Trojan Nuclear Plant  
Docket 50-344  
License NPF-1

PGE Response to the May 14, 1980  
NRC Request for Additional Information  
on the Auxiliary Feedwater System

FIG-I

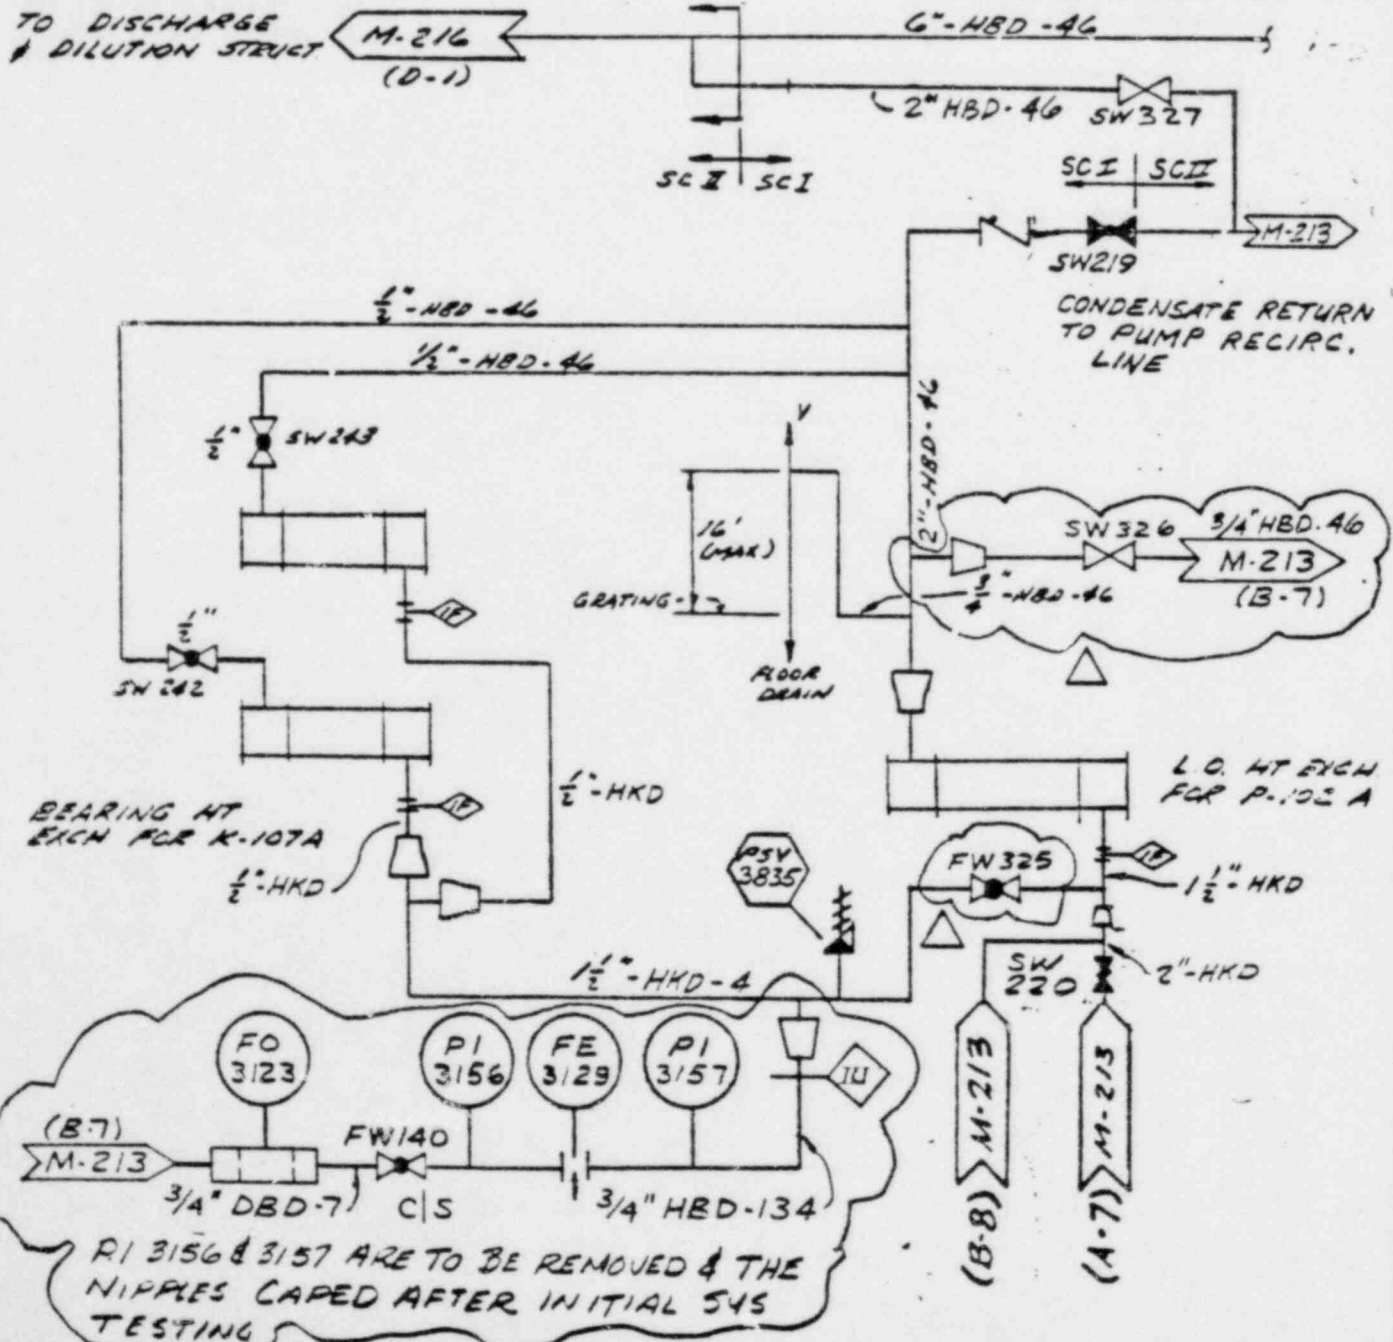
The Licensee's response to this recommendation is not complete. The Licensee should provide a description including the appropriate drawings of the modifications to be performed to ensure that the turbine-driven AFW pump, its associated systems and flow path will automatically provide adequate AFW flow for at least 2 hr. during a loss of all a-c power condition.

The turbine-driven AFW pump and its associated systems are being modified in two parts to achieve an a-c power independence. First, the cooling water system to the turbine-driven AFW pump, previously supplied from service water booster pumps, has been modified to accomplish a closed system of self-cooling. This modification provides cooling water circulation from the pump third-stage crossover through the lube oil bearing coolers and back to the pump suction (see attached Figures 1 and 2).

FIG. 4  
**INTERIM  
DRAWING CHANGE  
NOTICE**

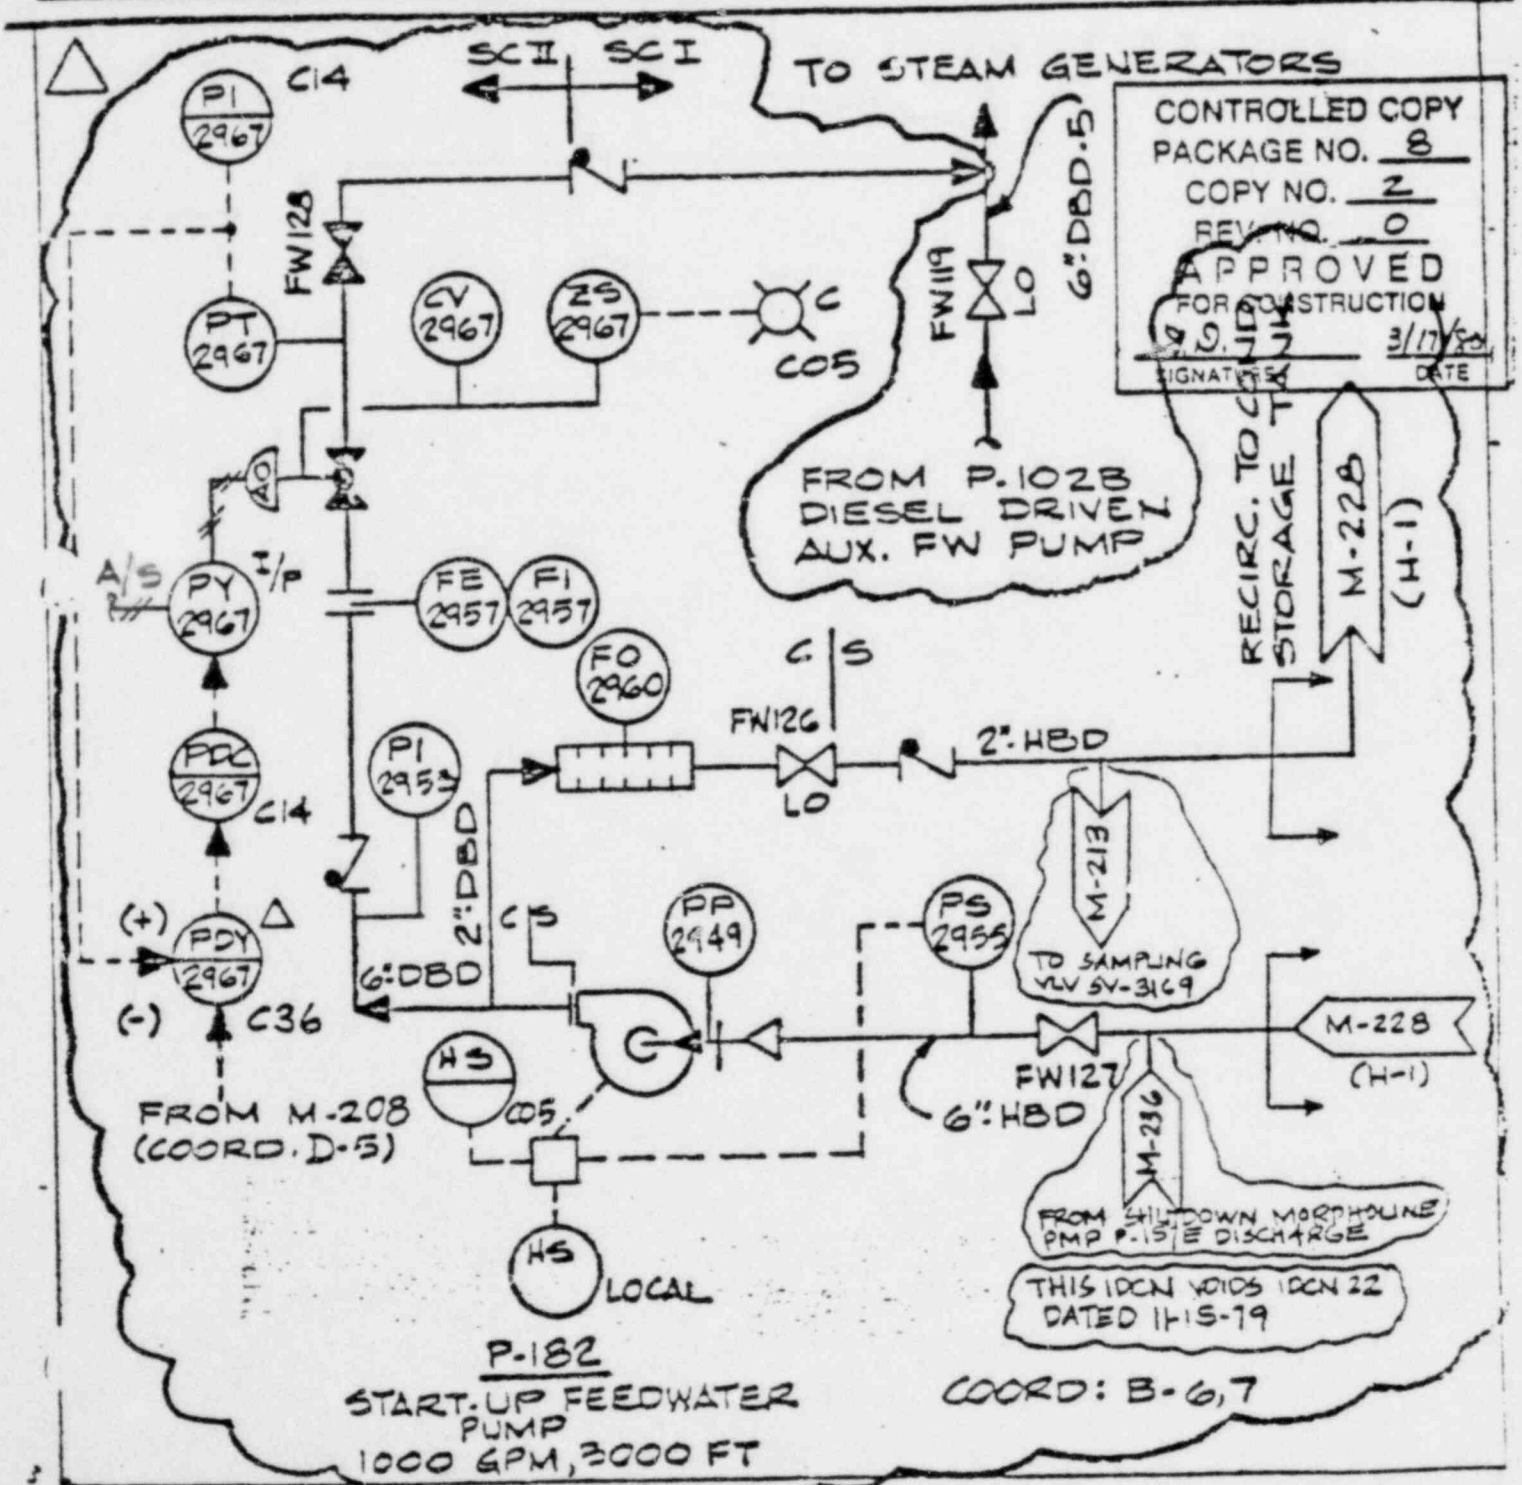
The Licensee's response to this recommendation is acceptable. However, the Licensee should provide us with copies of the revised AFW system drawings for the additional motor-driven pump.

We are presently modifying the Trojan plant P&ID to reflect design change of additional motor-driven AFW pump. The final revision of the P&ID has not been completed; therefore, for your information, we have attached a copy of the Interim Drawing Change Notice (Figure 4) and a sketch describing the motor-driven pump (Figure 5).

Reason for change: WRITTEN AGAINST REV. 18 FOR RDC-77-139(M) TO ADD START-UP FEEDWATER PUMP SYSTEM PER (P-9943)
